## CITY OF MENDOTA HEIGHTS

### PLANNING COMMISSION REGULAR MEETING AGENDA

August 26, 2025 at 7:00 PM  
Mendota Heights City Hall, 1101 Victoria Curve, Mendota Heights

**B) PLANNING CASE 2025-12  
M&M HOME CONTRACTORS, 1867 HUNTER LANE – MISSISSIPPI RIVER CORRIDOR CRITICAL AREA (MRCCA) PERMIT**

SHEET NO.: L-102

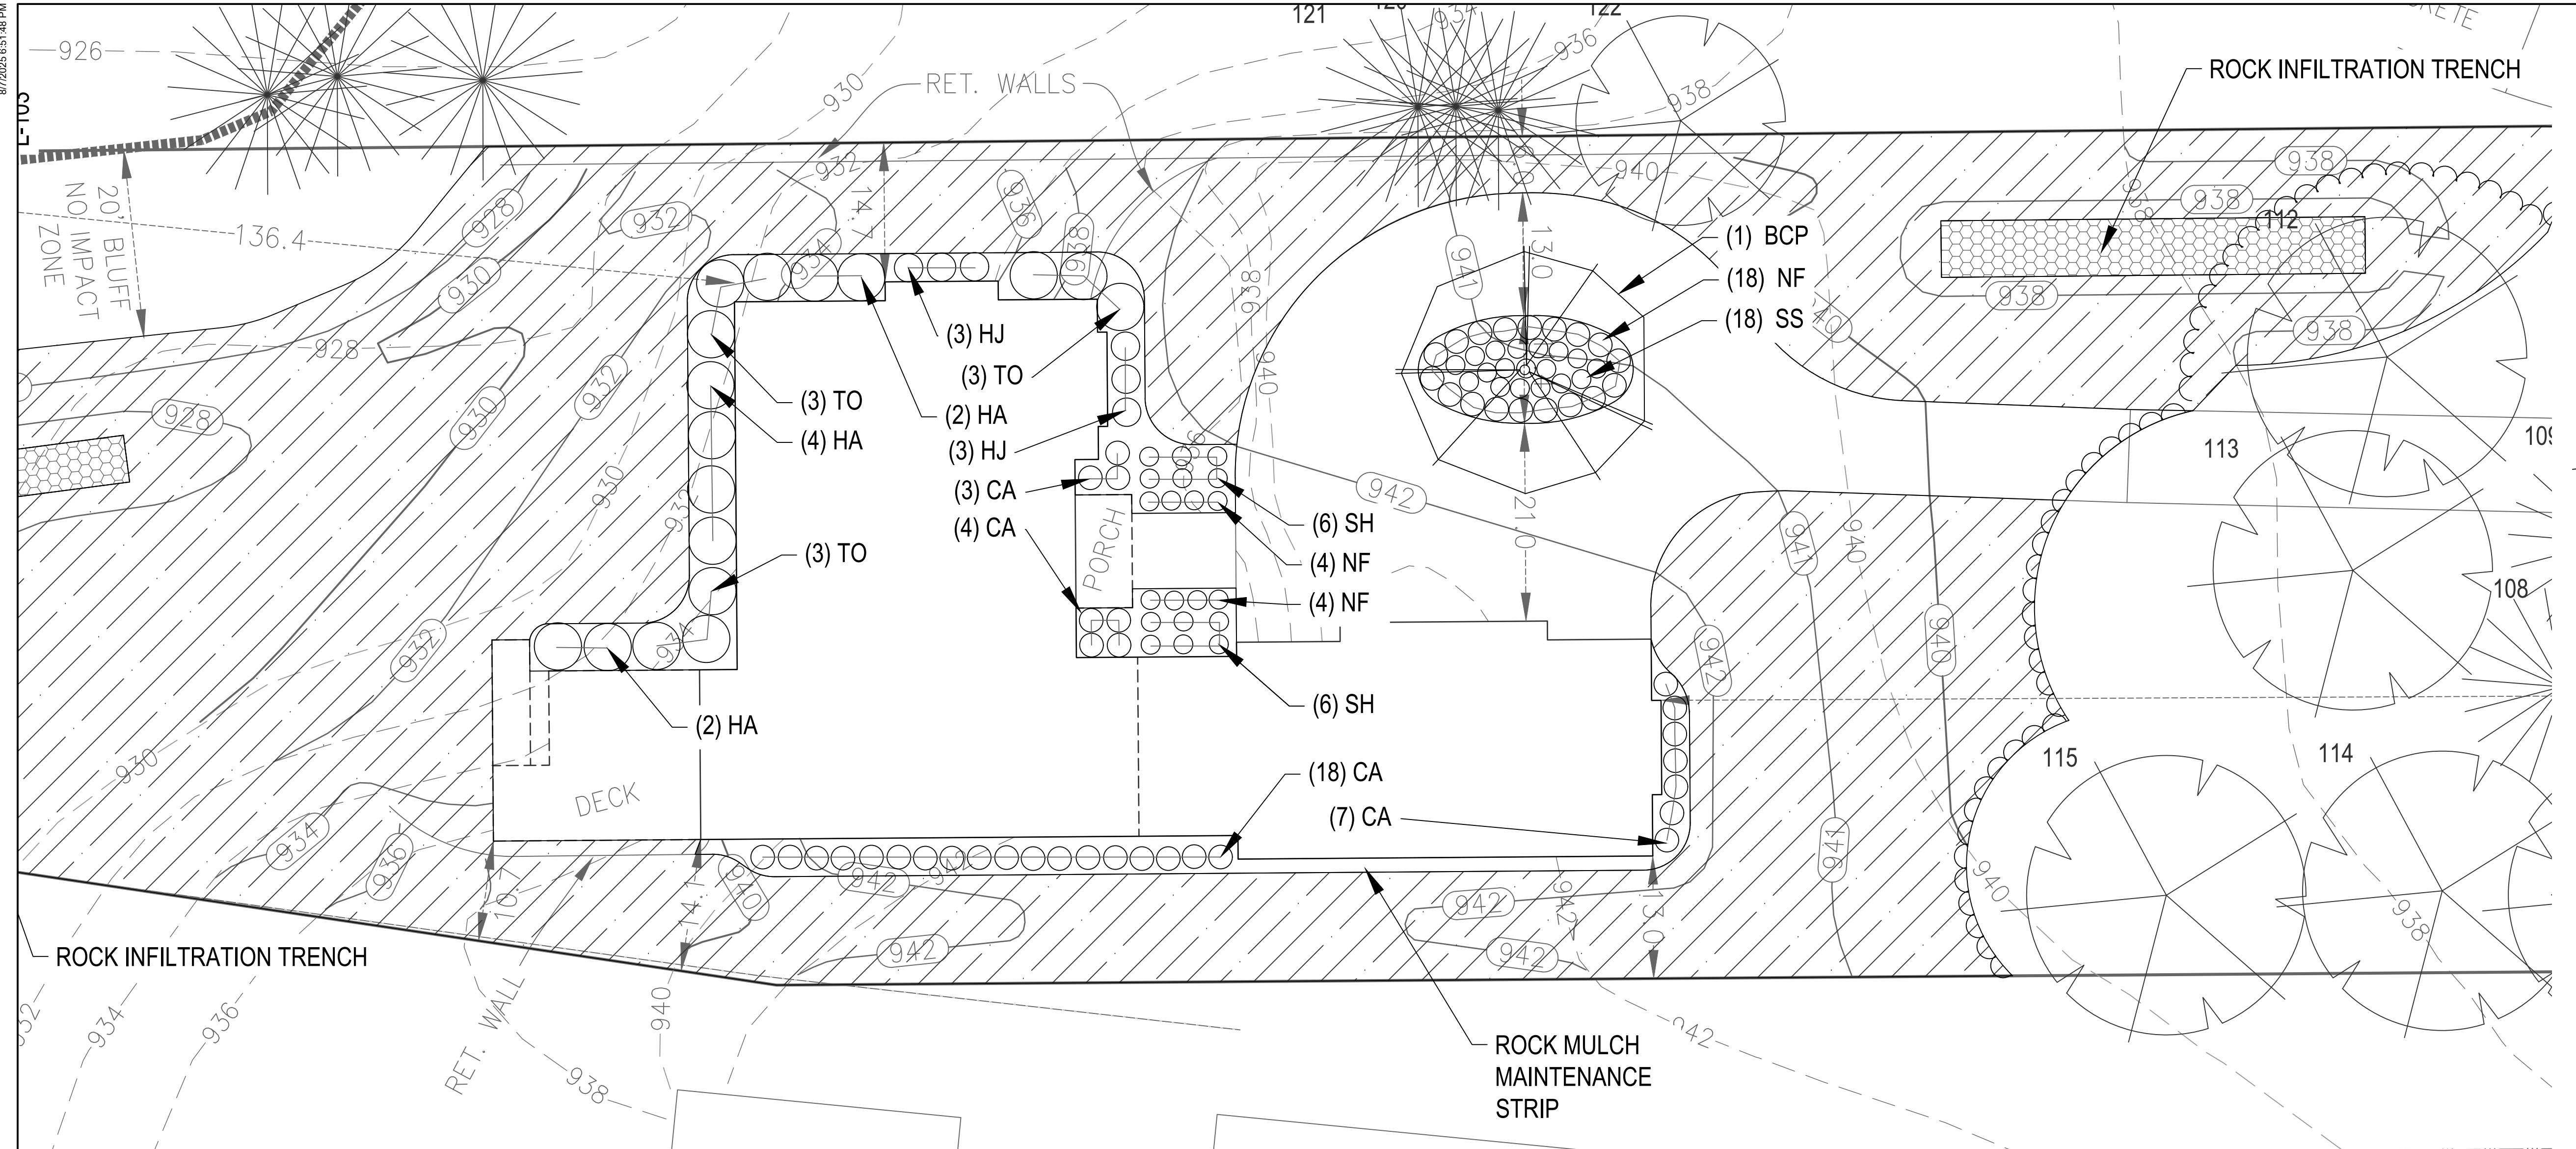
Commissioner Johnson commented that she feels that this application is incomplete as details are missing from the landscaping plan.

Commissioner Stone commented that he would think that a house of this scale would have more landscaping than two trees and would hope that the landscaping plan would be provided at the next meeting.

Commissioner Johnson stated that while she understands and appreciates that, the intention of the applicant is to plant more. She stated that if the intention is to have just two trees and sod, then

During discussion of the application, the Commission expressed concerns with the available details on proposed landscaping for the new home site, and requested additional information from the applicant. The applicant was unable to attend the July 22nd meeting and verbally address the Commission's questions and the comments which arose from residents attending the public hearing, leading to the Commission voting to Table the application. The applicant has provided updated landscaping plans and details which are included as an attachment to this report. An updated survey has also been provided illustrating the location of existing trees on the property.

Community Development Manager Sarah Madden commented that the Commission has debated this issue before, and it comes down to a difference in interpretation of the minimum requirements. She stated that while minimal, the applicant has provided a plant schedule that identifies two swamp white oaks as the two trees. She stated that it is not a full landscape schedule of all perennial beds, which would be a preference of the Commission, but the minimum landscape requirements of the City would be for two overstory trees, and the applicant has met that requirement.

Commissioner Nath commented that without written requirements in Code, the issue is very subjective. He stated that he would see this to be a complete landscaping plan as it meets the requirements of the City Code, although Commissioner Johnson would like to see more information. He noted that while Commissioner Johnson would deem this landscaping plan as incomplete, he would consider it to be the bare minimum. He stated that while he would love a more detailed landscaping plan, it is not required under Code.
